# Modification of Development Consent

**Development Consent:** SSD-9691 granted by the then Minister for Planning and Public Spaces on 8 April 2021

**For the following:** Staged construction of the Southlands Warehouse Estate

**Modification Application:** SSD-9691-Mod-2

Figure 1: Stage 1 works

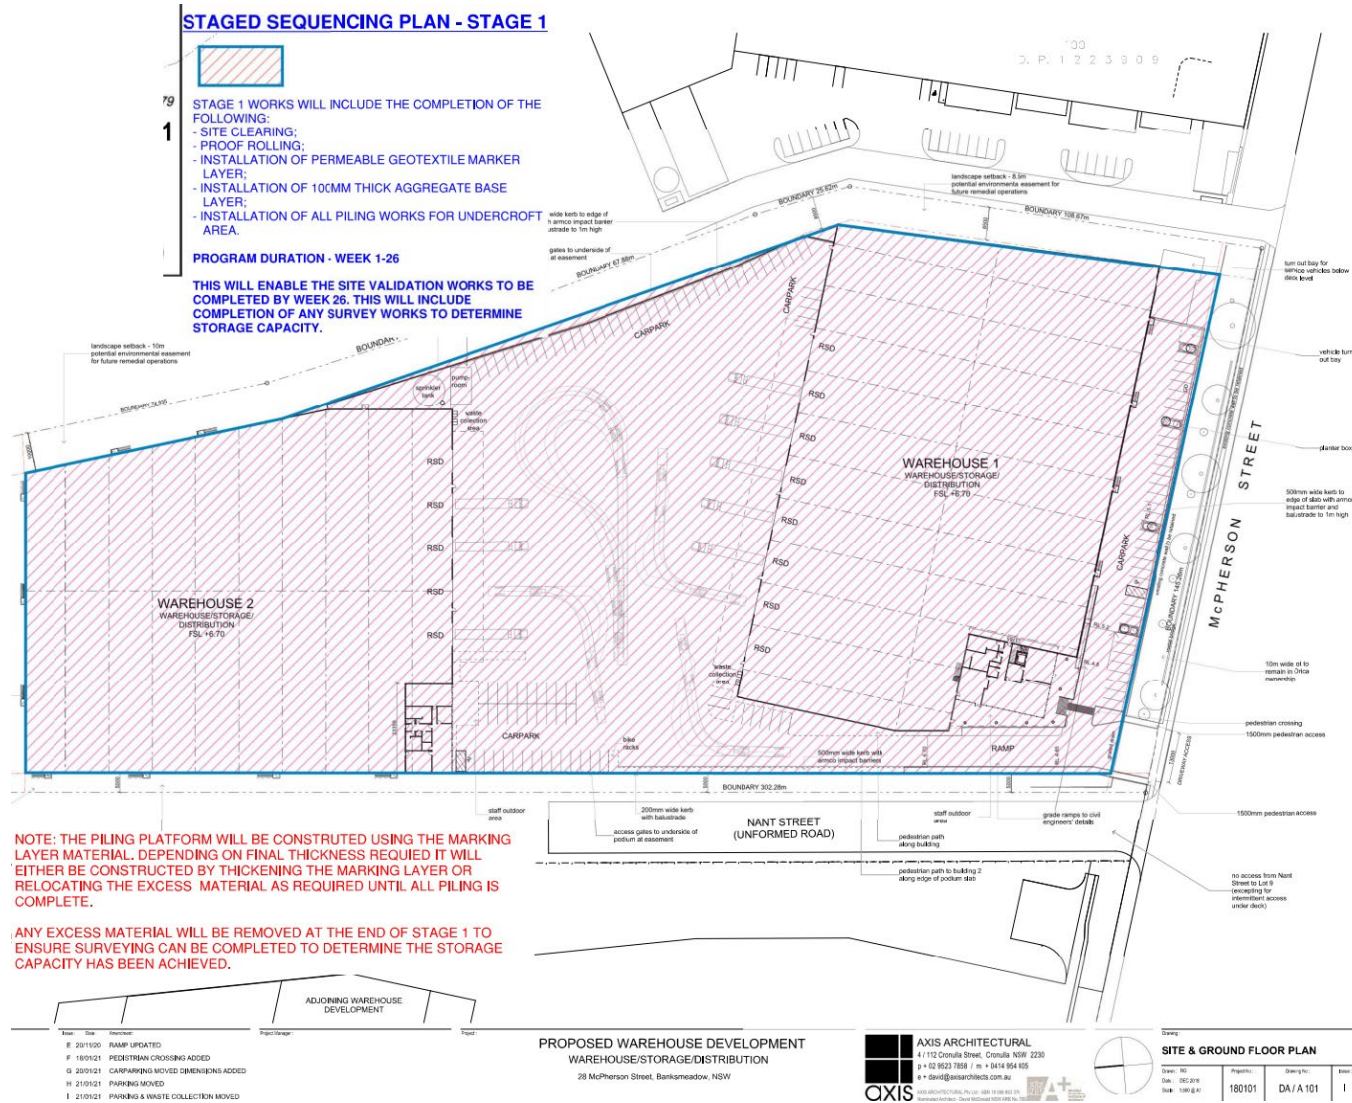
10. In Appendix 1 – Development Plans, delete the figures titled ‘Figure 1: Podium Slab Plant (Stage 1 works)’ and ‘Figure 2: Site & Ground Floor Plan (Stage 2 works)’.
11. In Appendix 1 – Development Plans, insert figures titled ‘Figure 1 – Stage 1 works’, Figure 2 – Stage 2 works’ and ‘Figure 3 – Stage 3 works’, as shown in Appendix A of this modifying instrument.

**Stage 1 works**            Site remediation works and construction of supports piers  
    **Stage 2 works**            Construction of suspended concrete deck in northern half of site and access ramp  
    **Stage 3 works**            Construction of Warehouse 2 and remaining suspended concrete deck  
    **Stage 4 works**            Construction of Warehouse 1  
    **Warehouse 1**            Warehouse 1, as denoted on plans in Appendix 1  
    **Warehouse 2**            Warehouse 2, as denoted on plans in Appendix 1
3. In the definition for “operation” delete the words “The use of the two warehouses” and replace with the words “The use of one or more of the warehouses”.
